Town of Hilton Head Island Regular Design Review Board Meeting

November 10, 2015

**Town of Hilton Head Island
Design Review Board
Minutes of the Tuesday, October 27, 2015 Meeting
1:15p.m. – Benjamin M. Racusin Council Chambers**

A3.0
© 2015 Peninsula Associates Architects, LLC

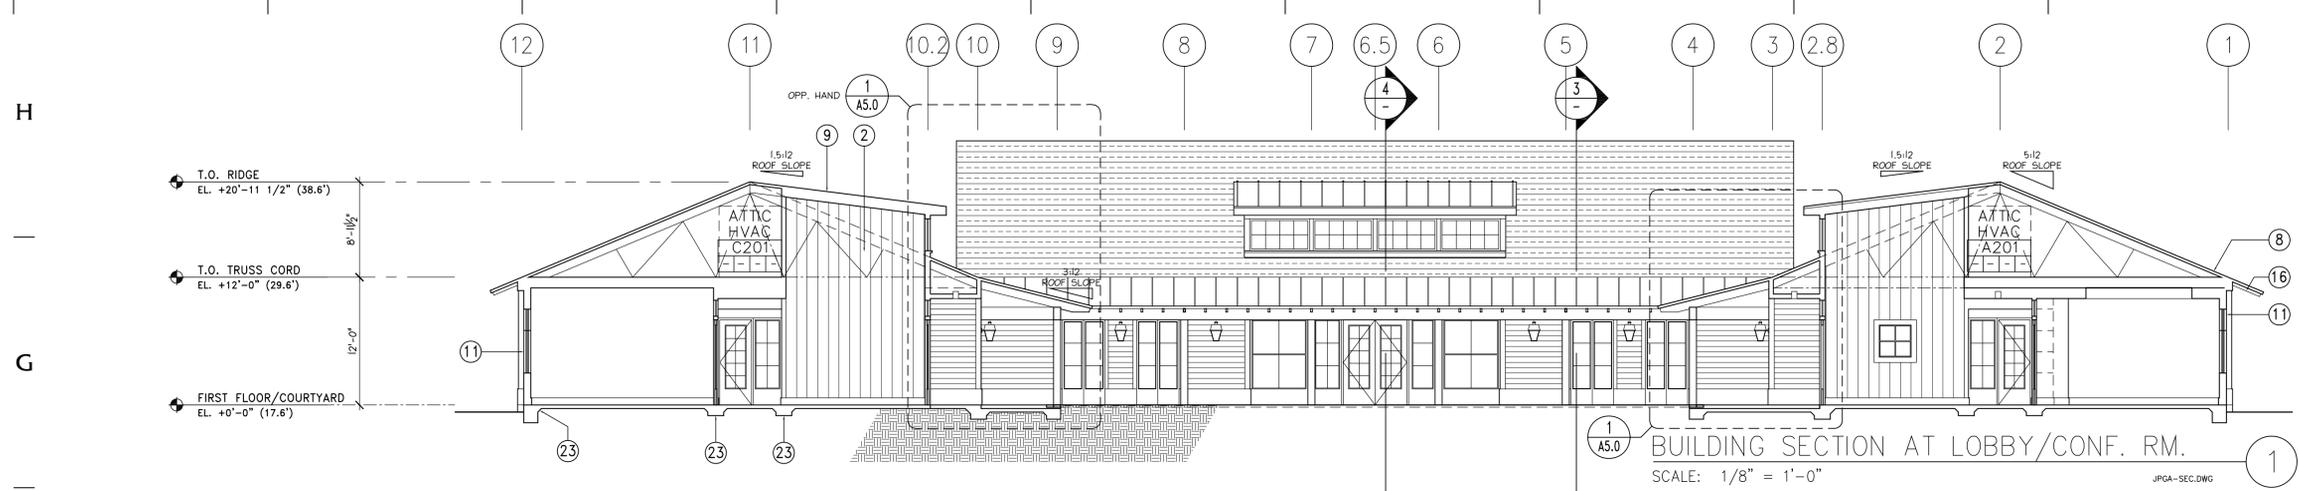
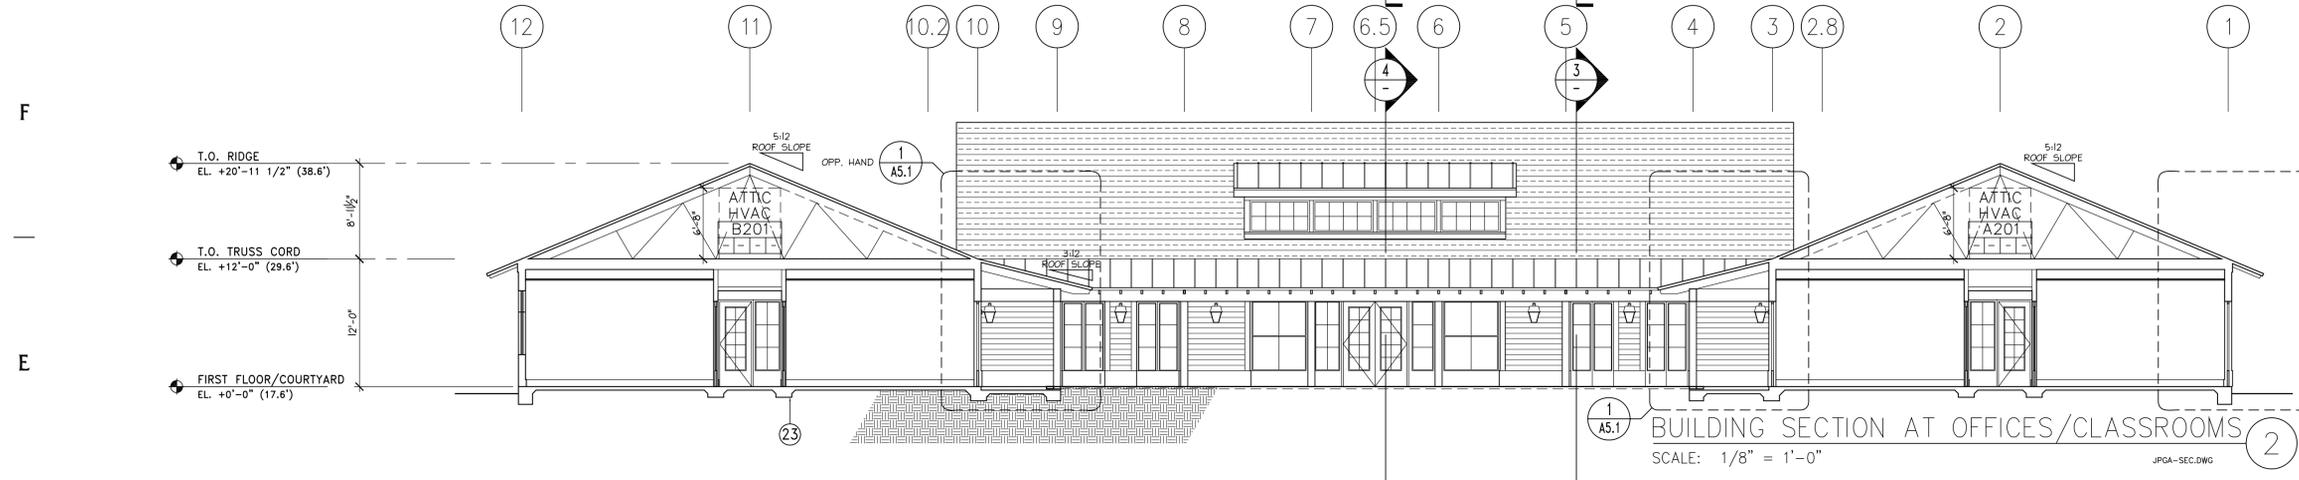
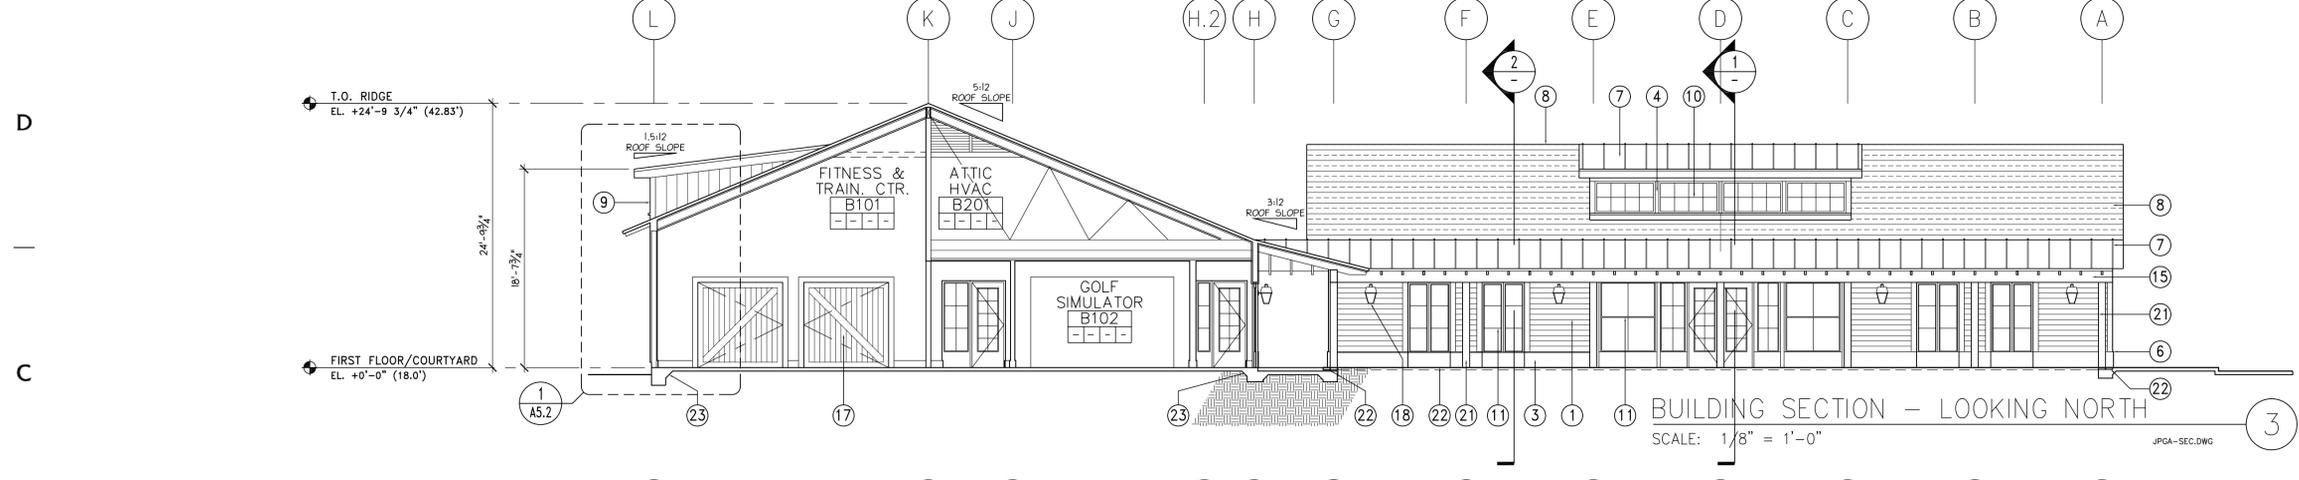
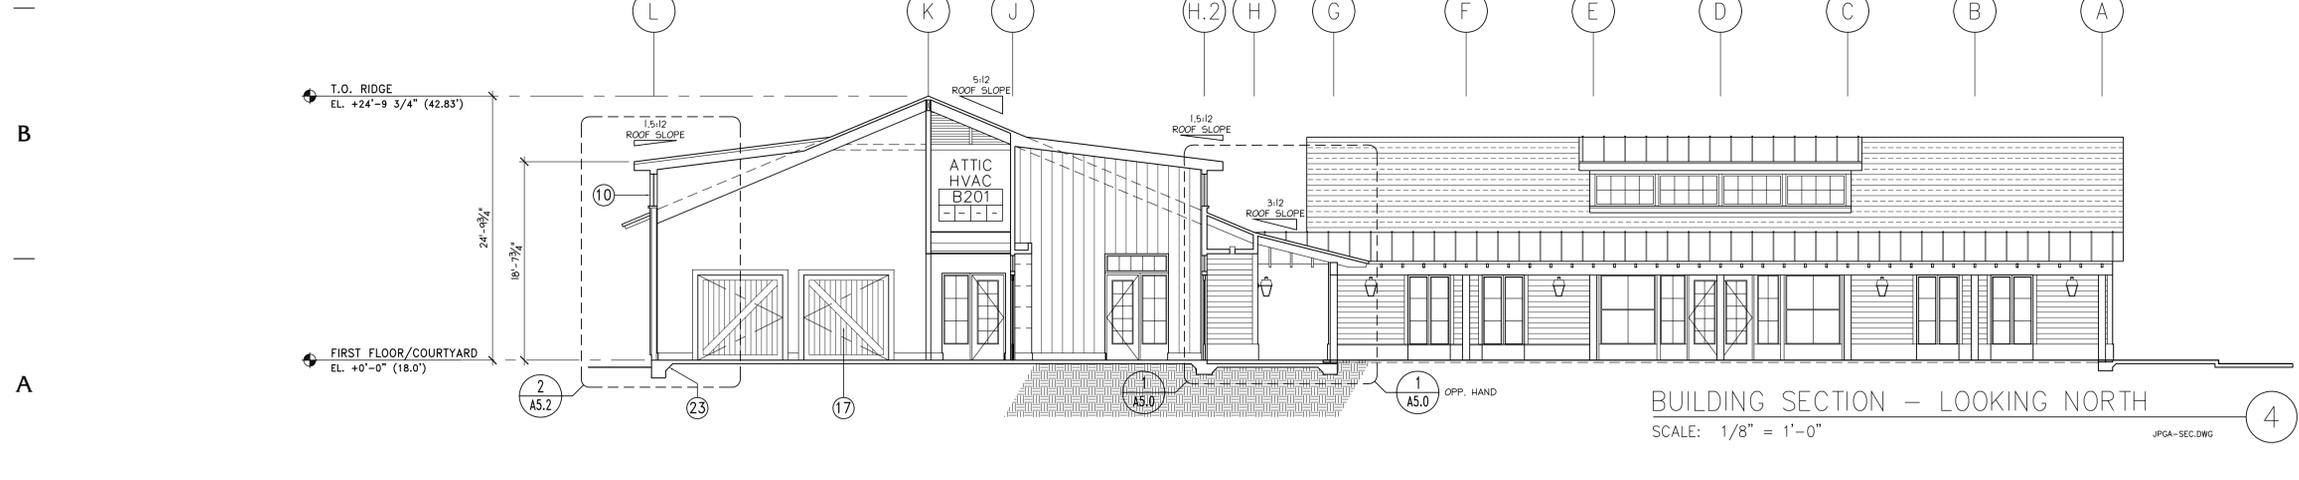
(2) Additional detailing shall be added at the rear façade of the Fitness & Training Center Building, suggest shutters in the closed position;

The 3:12 roof configuration and slopes have been resolved and graphically corrected in the Building Elevation Sheet A3.0. This condition appears on the north and south ends or "bumps" of the Fitness & Training Center Building. While the roof slope of 3:12 is maintained on the Courtyard side, the roof slope transitions to a 1.5:12 slope at Grid Lines #3 and #10. This roof slope is consistent with all dormer slopes. See Reflected Ceiling Plan for additional roof/eave/overhang information.

We are showing the addition of four (4) 3'-0" x 3'-0" fixed glass windows in between the dormers as designed and reviewed earlier. These window sills are roughly 8'-0" off the finish floor, allowing the mirrors inside to "slide" underneath the sills. The added glass windows will bring in welcomed natural light into the space, with no "blind" shutters required.

Additionally, please note that on the sheet A3.0 Building Elevations, we needed to add mechanical intake/exhaust louvers at the gabled end of the buildings. We anticipated that these would be needed and did not want any vents/pipes daylighting through the roof. As shown and noted, these intake/exhaust wood slat louvers will be seamlessly integrated into the overall architectural composition of each gabled end, and will be painted to match the siding color.
